Subject: Transmittal of Revision 1 To Service Bulletin Number
V25000-ENG-72-0363.

International Aero Engines SERVICE BULLETIN

ENGINE - PROVIDE NEW FIRST AND SECOND STAGE TURBINE AIR SEALS

V2500-ENG-72-0363

HPT Rotor and Stator Assembly
Ref. Catalog Sequence No 72-45-00. Fig. 1 Item 100.
Figure 1 (Sheet 1 of 2)

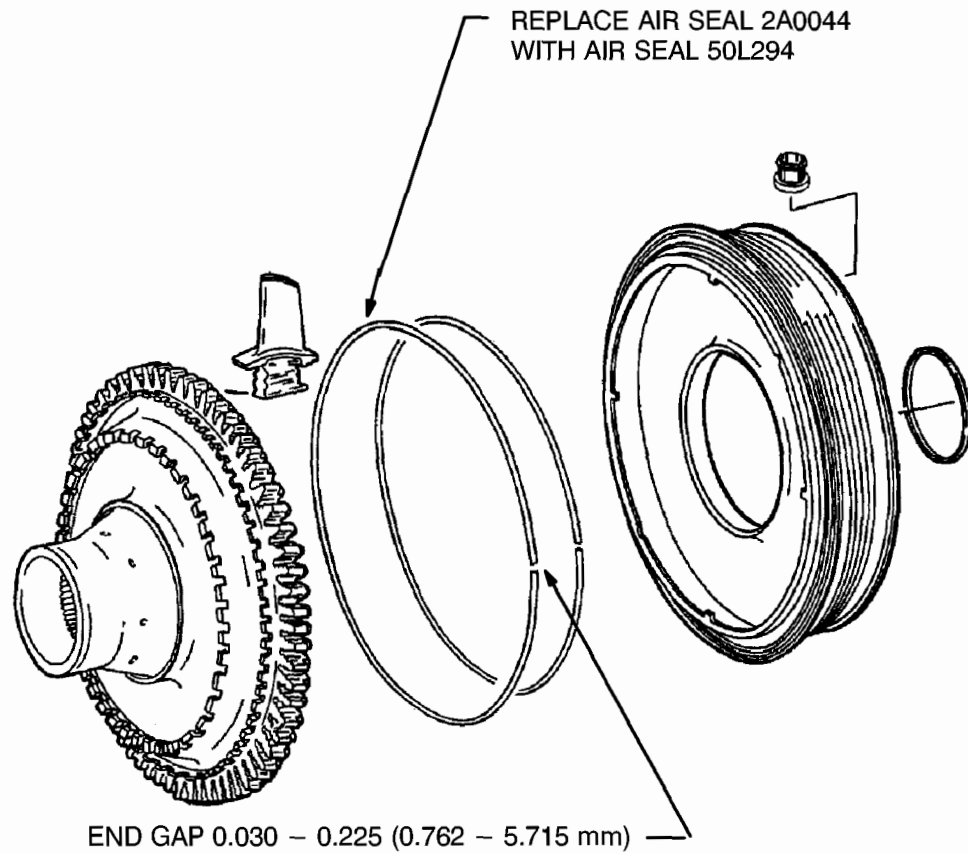
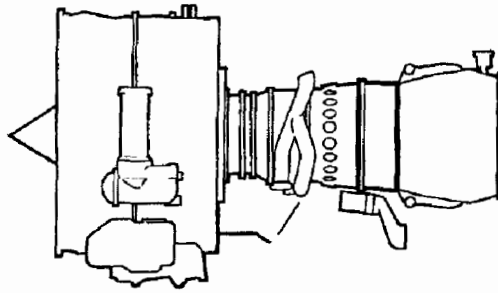
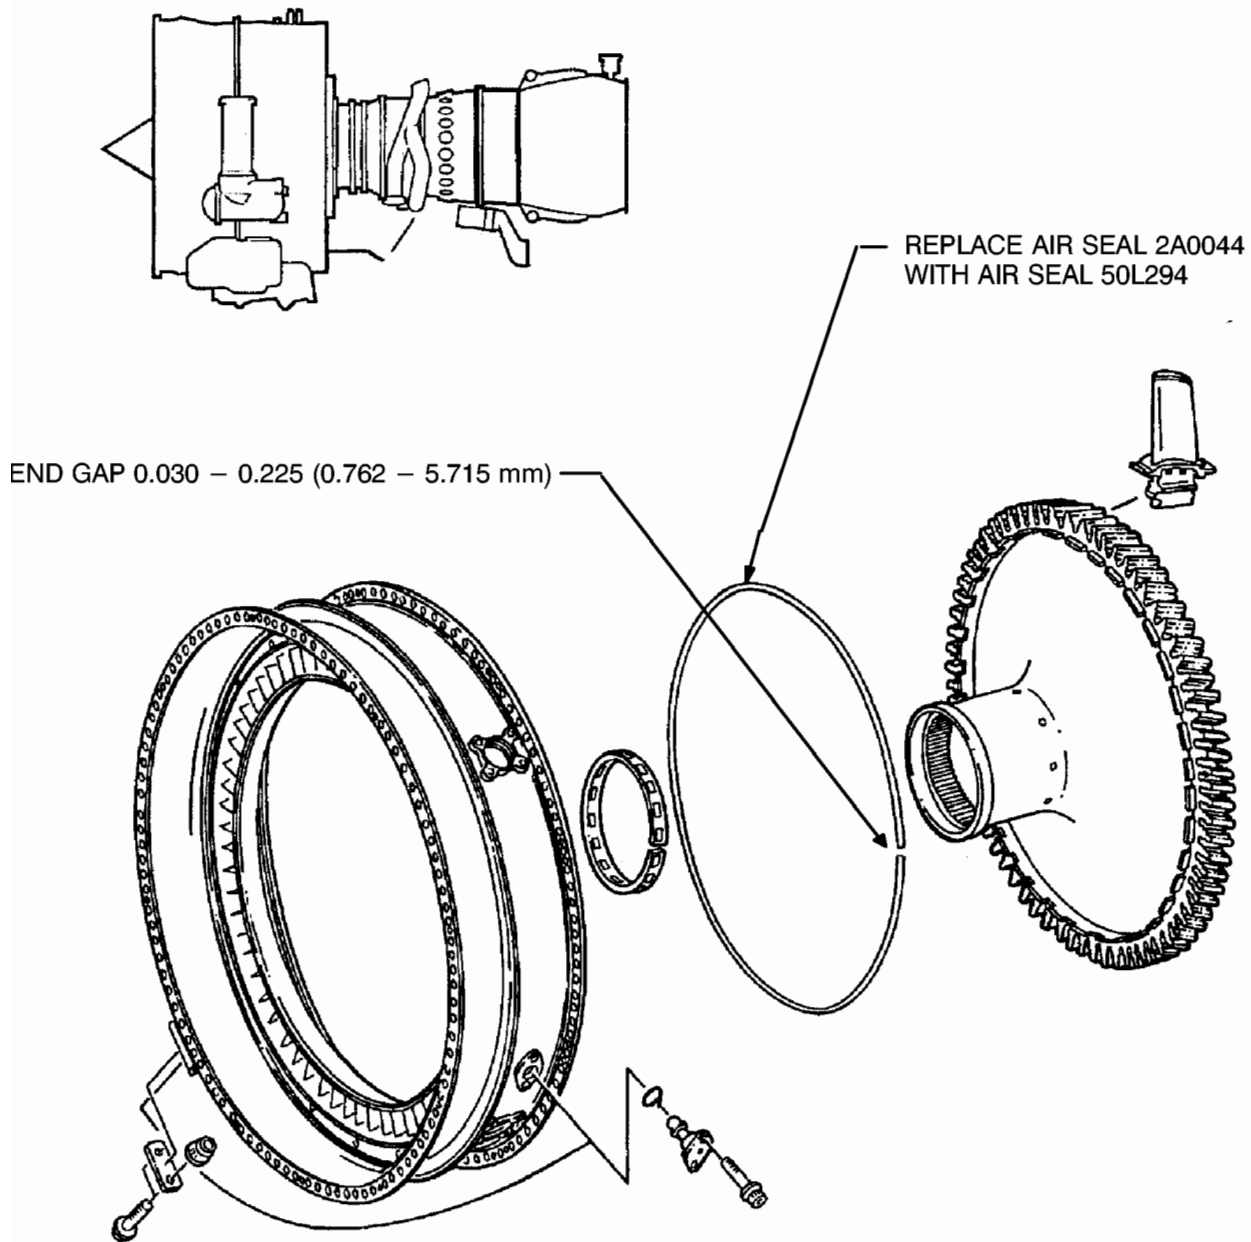
- B. Replace the 2A0044 Seal, 1st and 2nd Stage HPT (2 off) with Seal 50L294 when you assemble the HPT Rotor and Stator Assembly by the procedure specified in Reference 2, Chapter/Section 72-45-00. See Figure 1.

- A. Cut a length of seal wire 72.5 inch (1841.5 mm) from part number 50L294 roll for each new seal required. At assembly trim the seal wire to maintain an end gap of 0.030 - 0.225 inch (0.762 - 5.715 mm).

Stage 1 HPT Air Seal (Outer)
Ref. Catalog Sequence No 72-45-12. Fig. 1 Item 010.
Figure 2

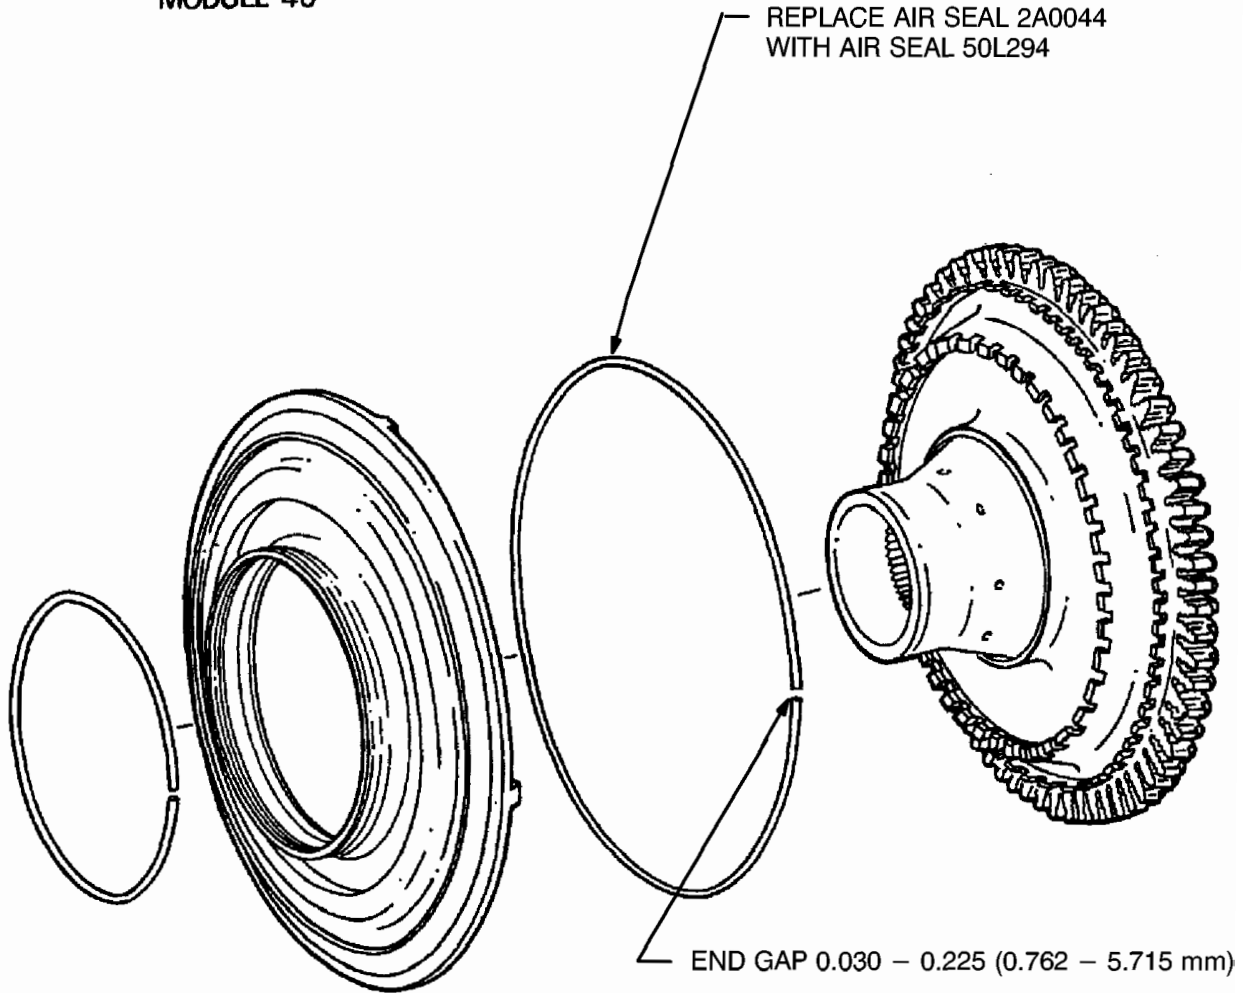
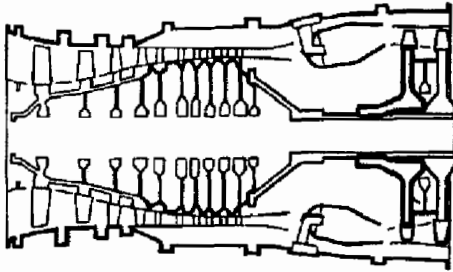
- C. Replace the 2A0044 Seal, 1st and 2nd Stage HPT (1 off) with Seal 50L294 when you assemble the Stage 1 HPT Air Seal (Outer) by the procedure specified in Reference 2, Chapter/Section 72-45-12. See Figure 2.

Stage 1 High Pressure Turbine Blade Assembly
Ref. Catalog Sequence No 72-45-14. Fig. 1 Item 060.
Figure 3

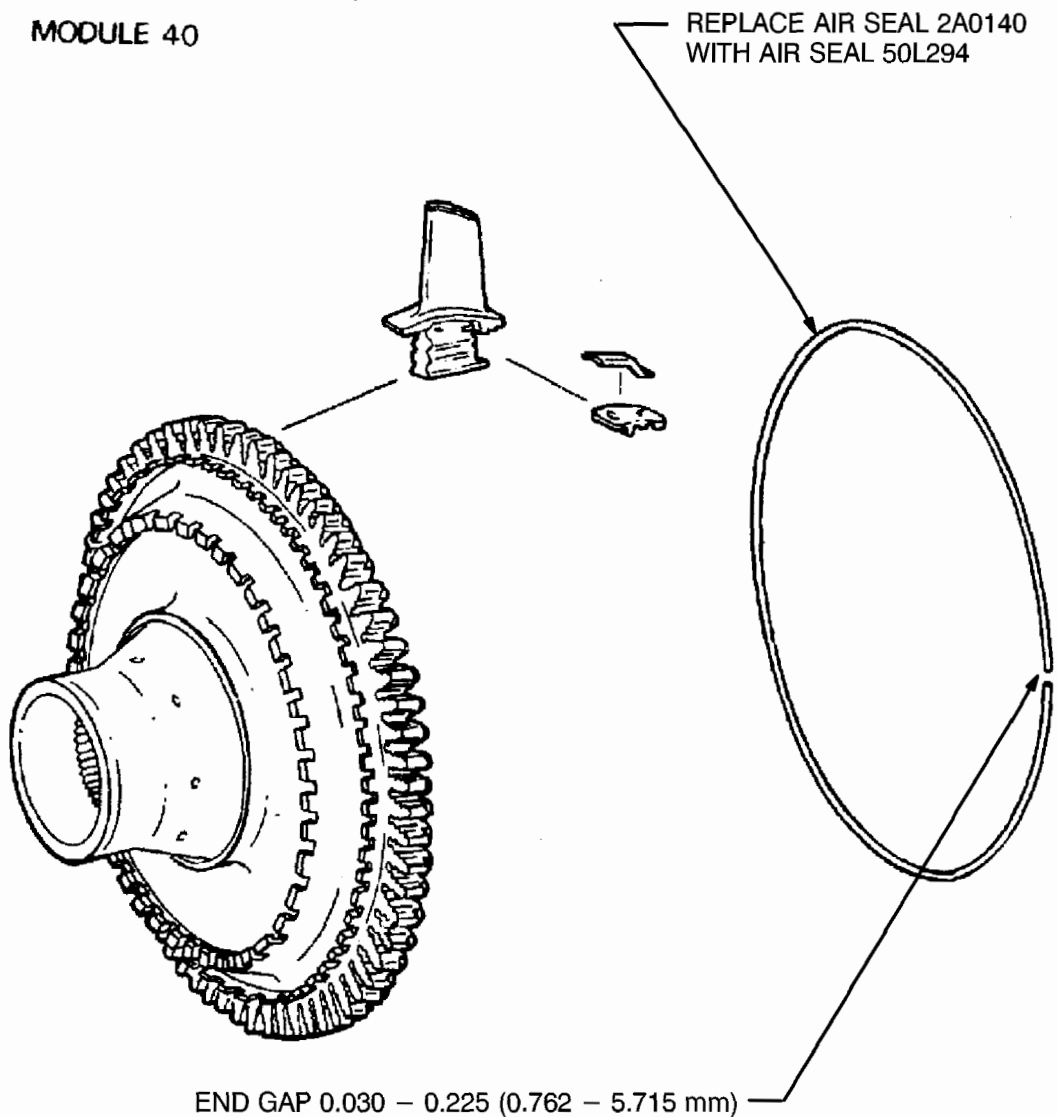
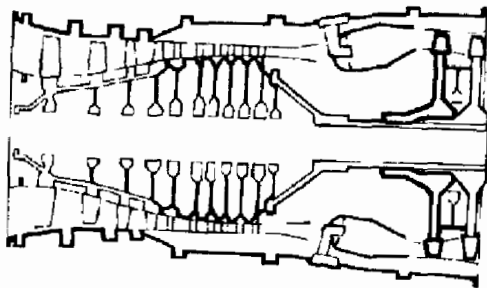
- D. Replace the 2A0140 Seal, 1st and 2nd Stage HPT (1 off) with Seal 50L294 when you assemble the Stage 1 High Pressure Turbine Blade Assembly by the procedure specified in Reference 2, Chapter/Section 72-45-14. See Figure 3.

Stage 2 HPT Blade Retaining Plate
Ref. Catalog Sequence No 72-45-33. Fig. 1 Item 010.
Figure 4

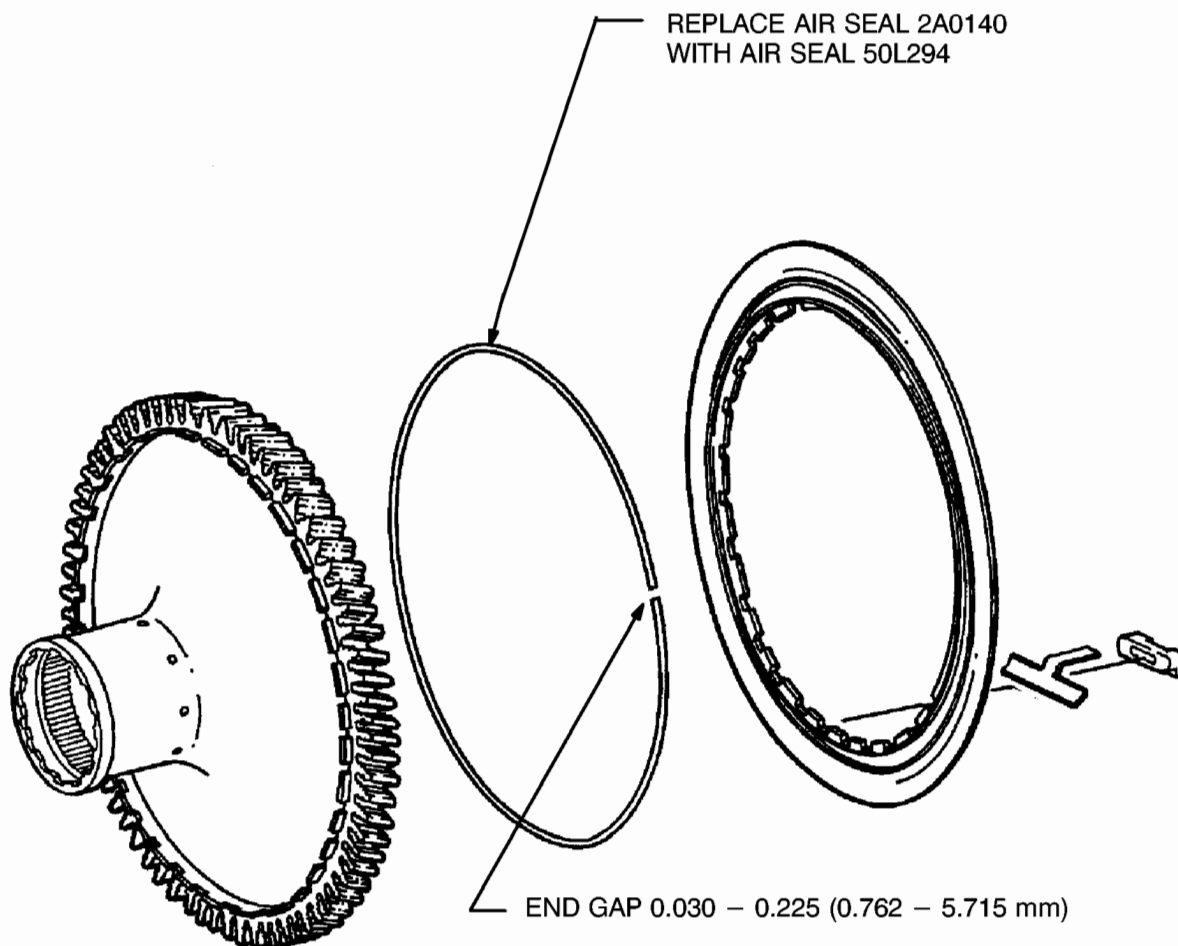
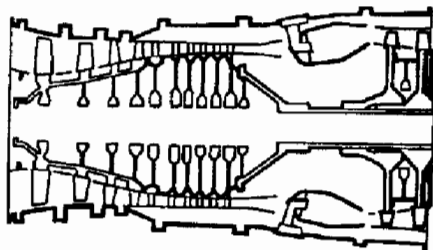
- E. Replace the 2A0044 Seal, 1st and 2nd Stage HPT (1 off) with Seal 50L294 when you assemble the Stage 2 HPT Blade Retaining Plate by the procedure specified in Reference 2, Chapter/Section 72-45-33. See Figure 4.
